CITY OF CODY  
PLANNING, ZONING AND ADJUSTMENT BOARD  
TUESDAY, JULY 24, 2012  
CITY HALL COUNCIL CHAMBERS @ 12:00 NOON

**CITY OF CODY  
PLANNING, ZONING AND ADJUSTMENT BOARD  
STAFF REPORT**

<b>MEETING DATE:</b>	JULY 24, 2012	<b>TYPE OF ACTION NEEDED</b>	
<b>AGENDA ITEM:</b>		P&Z BOARD APPROVAL:	X
<b>SUBJECT:</b>	SPECIAL EXEMPTION PUBLIC HEARING: REDUCE FRONT SETBACK REQUIREMENT FOR 614 6 <sup>TH</sup> STREET SUP 2012-07	RECOMMENDATION TO COUNCIL:	
<b>PREPARED BY:</b>	TODD STOWELL, CITY PLANNER	DISCUSSION ONLY:

Darin Samuels has submitted a Special Exemption application, requesting a six-foot reduction in the front setback requirement in order to construct a 26-foot wide by 30-foot deep garage on his home at 614 6<sup>th</sup> Street.

1 SITE PLAN  
A1.0

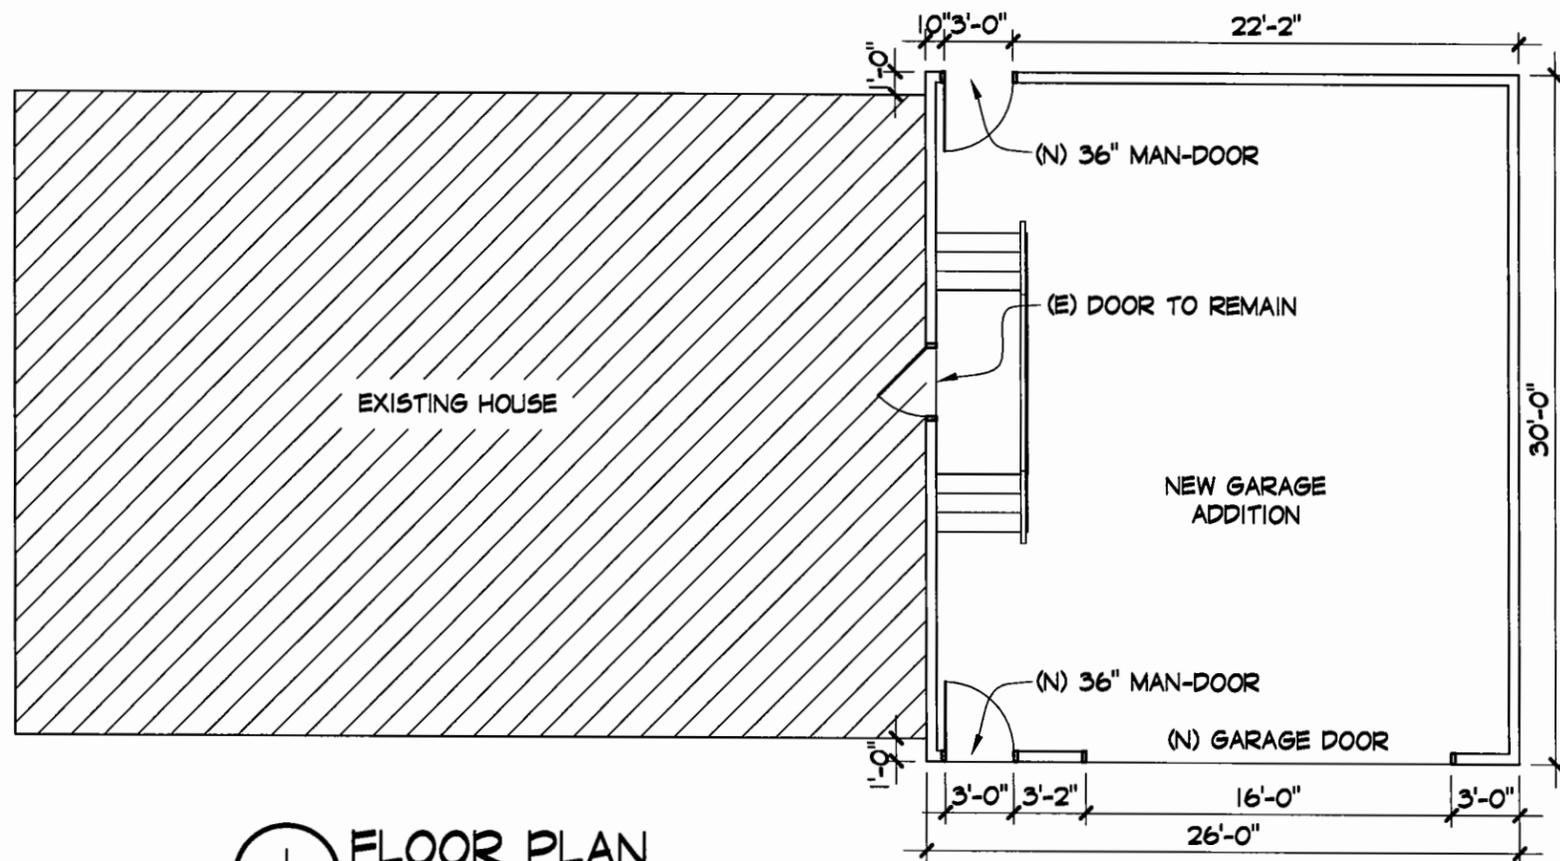
The property is within the Residential "A" zoning district, which requires a 25-foot front setback. A 19-foot setback is requested. The property is on the inside of a gradual curve, so the requested setback reduction is the greatest at the southwest corner of the garage. At the northwest corner of the garage, the garage will extend approximately one foot closer to 6<sup>th</sup> street than the existing house. Refer also to the enclosed drawing.

It is also noted that while the garage will be approximately 19 feet from the front property line, it will also be approximately 24 feet from the back of the existing sidewalk. Therefore, there will be adequate room to park a vehicle in front of the garage without having the vehicle overhang the sidewalk, as demonstrated in this photo:

Staff Comment: Many functional two-car garages are at least 24 feet wide. Due to the elevation difference between the existing house and the garage floor, steps will

be needed (see first photo). The location of the steps would necessarily utilize at least three feet of the interior garage, requiring additional width in the garage to accommodate two cars. The proposal is for a 26-foot wide garage, which just meets the 5-foot side setback at the rear of the garage. The depth of the garage is to accommodate a work bench at the back end. The garage cannot simply be located further from the street because with the angled lot line, the garage would not be able to meet the 5-foot side setback requirement. The Board can discuss whether the waiver is the "minimum necessary" if they have concerns.

Staff Comment: No additional services are proposed or needed for the garage, which do not already exist at the house. There may be utility services, such as the sewer and water lines that would be under the proposed garage site. The applicant will need to be sure any such service lines are protected. Utility locates will need to be conducted.

Staff recommends approval of the special exemption application to reduce the front setback requirement to approximately nineteen feet to allow construction of the garage, as proposed. The exemption is applicable only to the garage. A building permit will be needed.

PLAN VIEW

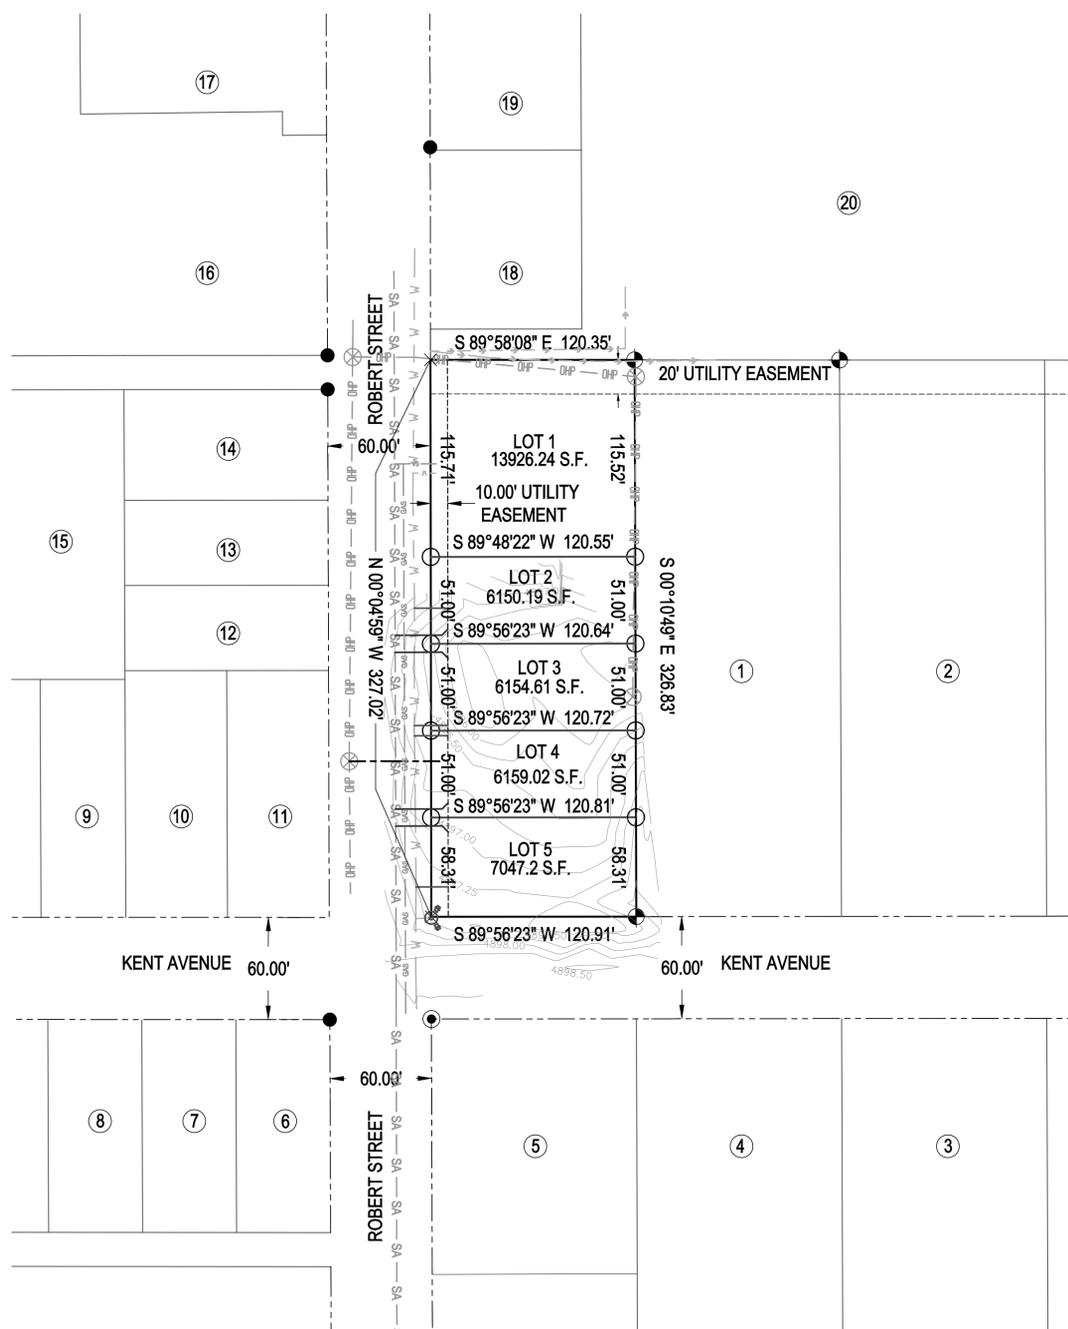
Staff Comment- No master-planned streets cross this property. Roberts Street is a designated collector street on the master street plan (typical cross-section attached). The typical cross-section for a collector is a 52' wide street, measured from back of curb to back of curb, with 4' sidewalks, located within an 80-foot wide right-of-way. Currently the right-of-way for Robert Street is 60 feet wide and it has been reconstructed just this month to a 28-foot wide paved surface—without curb, gutter, sidewalk or streetlights.

The right-of-way deficiency of Robert Street is not of concern to Planning and Public Works, provided a 10-foot utility easement is reserved along the Robert Street frontage of this property, as shown on the preliminary plat. Note that all physical improvements for a collector street, including sidewalk, can just fit within a 60-foot right-of-way.

Staff Comment: A small irrigation ditch runs along the north property line, apparently partially on, but partially off, this property. It runs to the east, serving the lots on the north side of Kent Avenue. The applicant asks for a variance to the piping of this ditch, as the ditch crosses only a small portion of the property at the northeast corner. This is a photo of the ditch-not the main ditch on the left side, but the smaller one on the right. The ditch is not part of the City irrigation system.

- A. From dedication of additional right-of-way for Robert Street. (Provide 10' utility easement instead.)
- B. From construction of curb, gutter, sidewalk, and streetlights along Robert Street and Kent Avenue frontages. (Agree to participate in future improvement district.)
- C. From the alley requirement.
- D. From covering (piping) of irrigation ditch along north property line.

**COVER SHEET**  
**Reno Collision Center**  
 2221 Lt. Childers Street  
 Cody Wyoming 82414  
 Phone: 307-527-5556 Fax: 307-527-5562

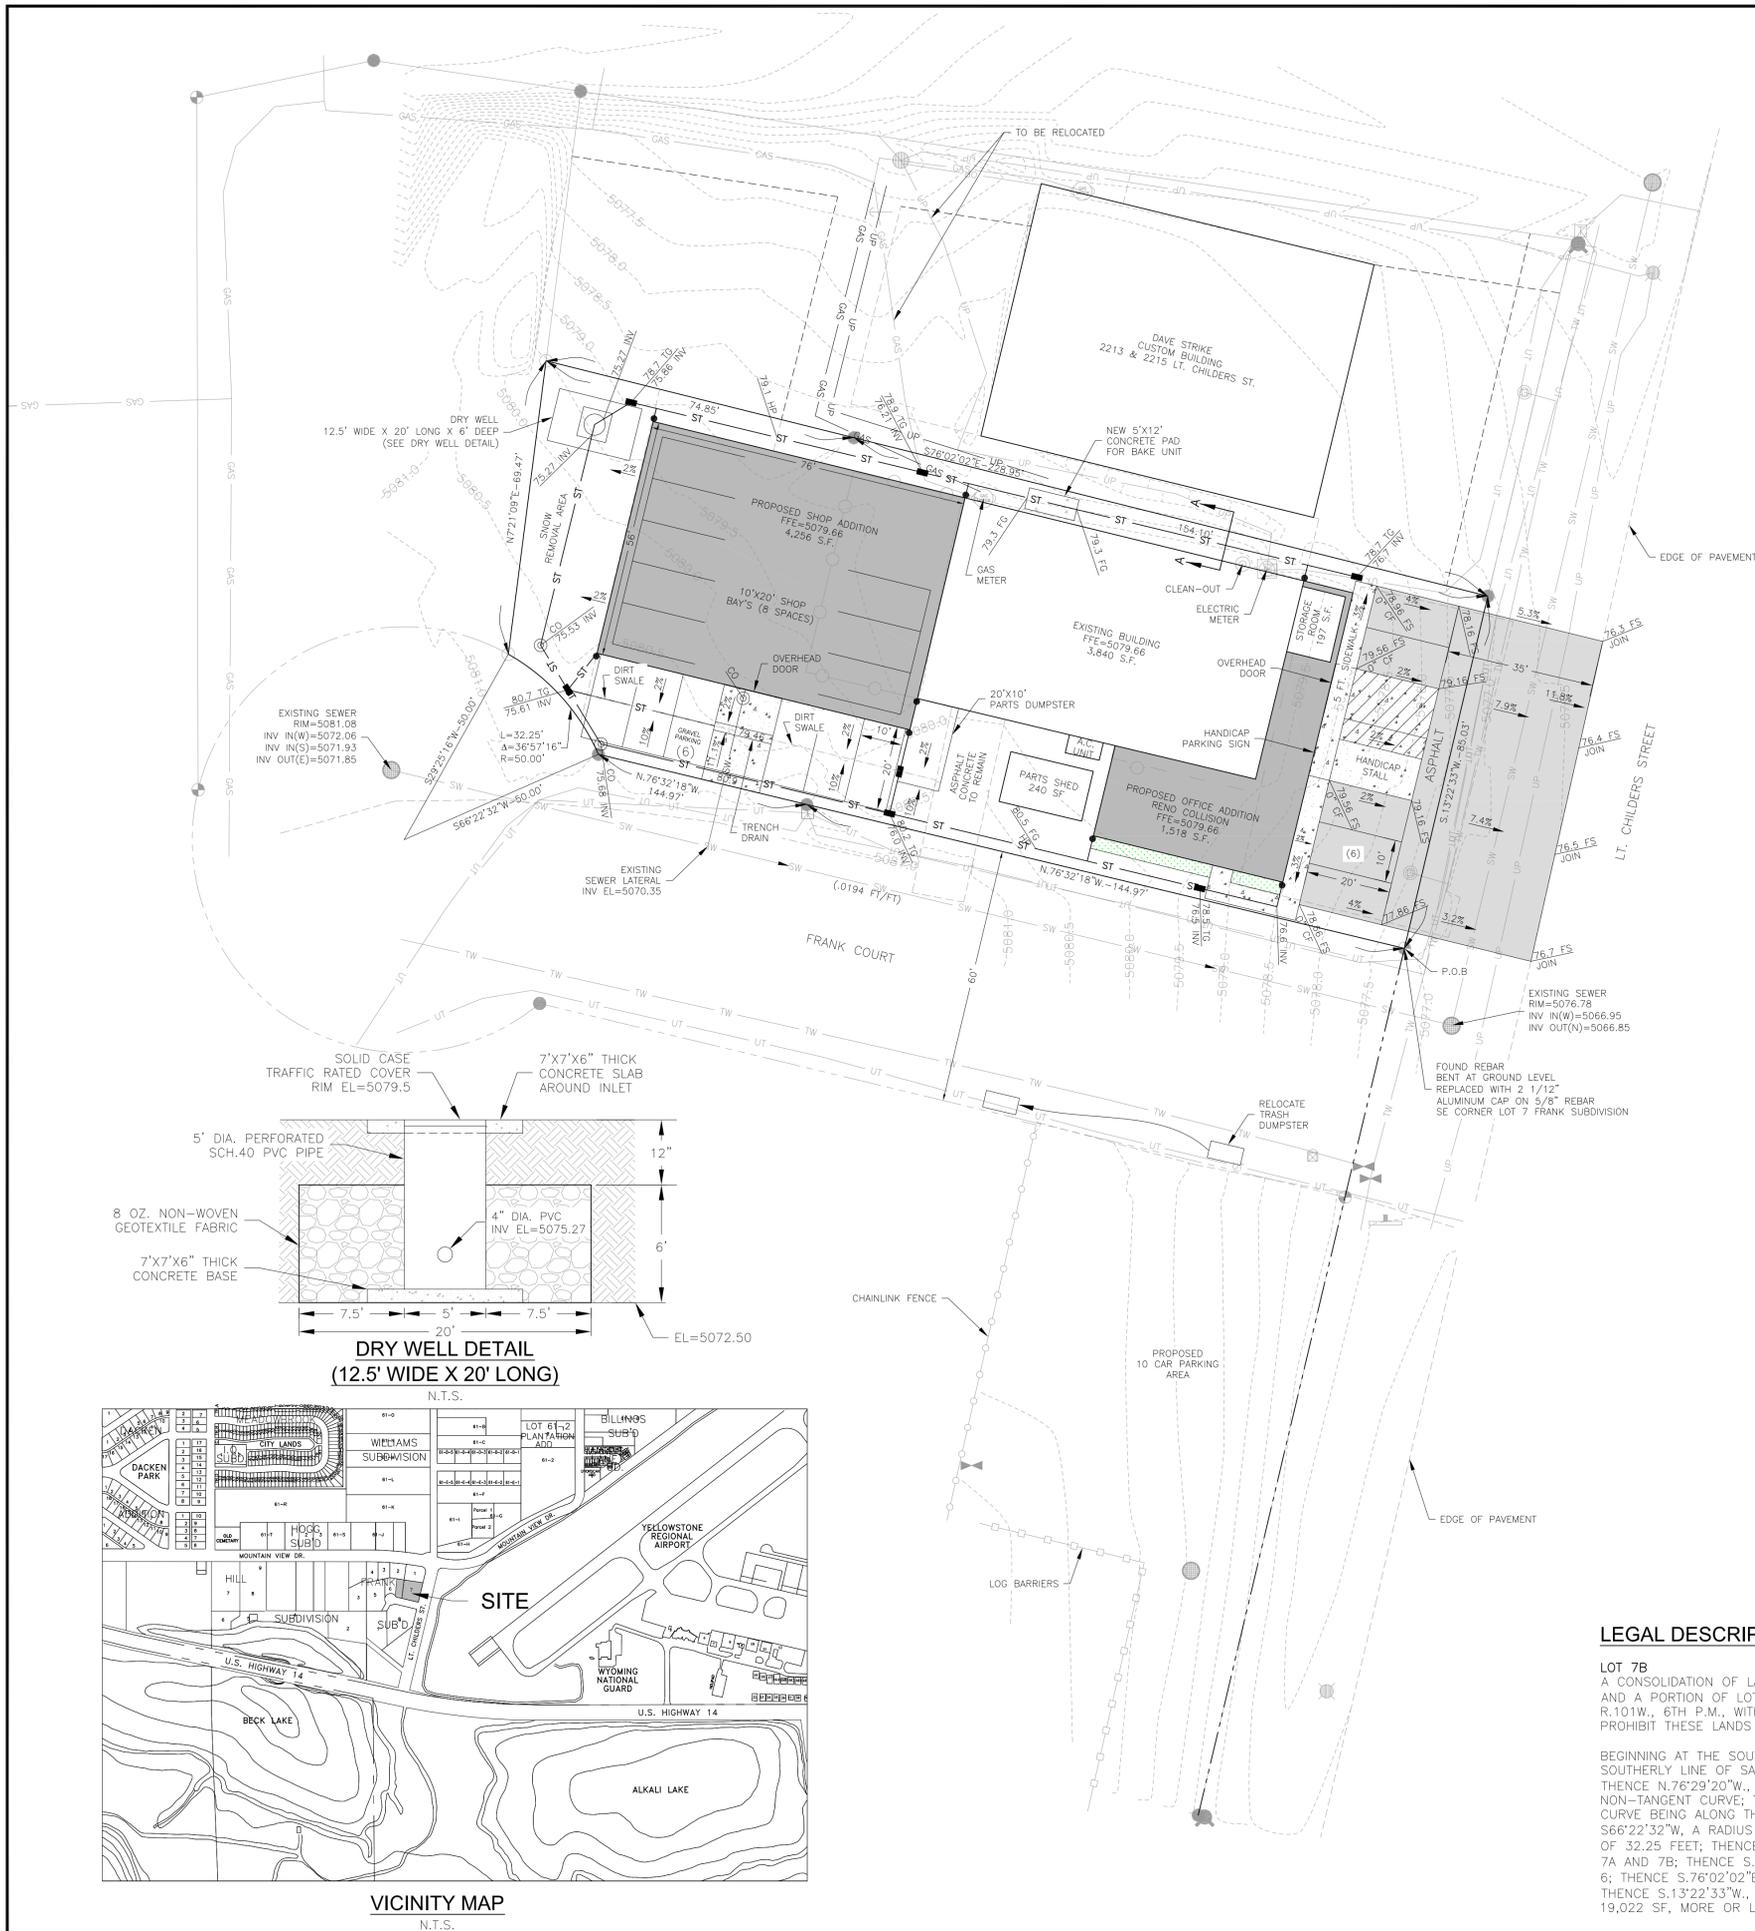
The parking ordinance requires one space per employee plus one space per average number of customers expected at any one time. The applicant indicates that with the addition there will be a capacity of 12 employees and no more than three customers at any one time, for a total need of 15 parking spaces according to the parking ordinance. The site plan includes twenty spaces on the site, between the outdoor and indoor spaces. All parking spaces meet the necessary dimensional requirements, with the exception of the ADA stall, which needs to be van-accessible (11' wide plus a 5' wide access aisle).

1. That the ADA parking space be modified to meet current dimensional standards.
2. That the size and connection details for the oil/water separator be provided with the building permit application.
3. That all storm water facilities be inspected and certified by the applicant's engineer.
4. That an encroachment permit be obtained for the work within the public right-of-way.
5. That verification of completion of the lot line adjustment be submitted with, or prior to, the building permit.
